**DEMONSTRATION / DELIVERY HOLD - Safety Recall 15S03**

Certain 2014 Model Year Transit Connect Vans Safety Belt and Cargo Hook Fastener Replacement

# CERTAIN 2014 MODEL YEAR TRANSIT CONNECT VANS — SAFETY BELT AND CARGO HOOK FASTENER REPLACEMENT

FIGURE 1

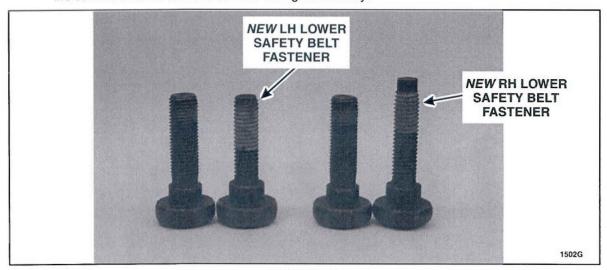
**NOTE**: While the upper safety belt fasteners are identical, the lower safety belt fastener for the RH side is longer than the lower safety belt fastener for the LH side. See Figure 1. Be sure to use the correct fastener kits for each side during reassembly.

FIGURE 2

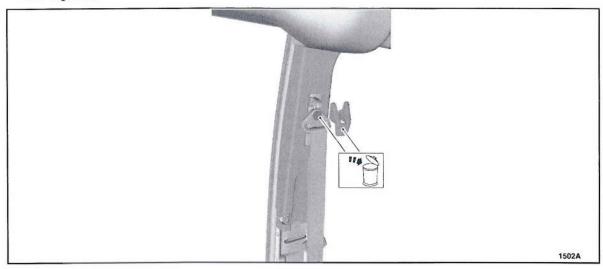
Remove and discard the D-ring cover and the D-ring fastener. Position the safety belt aside. See Figure 2.

- 3. Install the new lower safety belt fastener. See Figure 3.
  - Tighten lower fastener to 30 lb.ft (40 Nm).
- 4. Reposition the safety belt and install the new D-ring fastener. See Figure 2.
  - Tighten D-ring fastener to 30 lb.ft (40 Nm). Install the new D-ring cover.

FIGURE 3

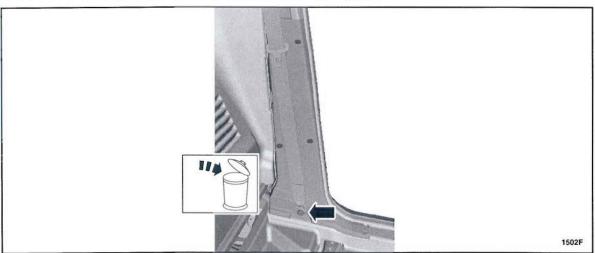
2. Remove and discard the lower safety belt fastener. See Figure 3.
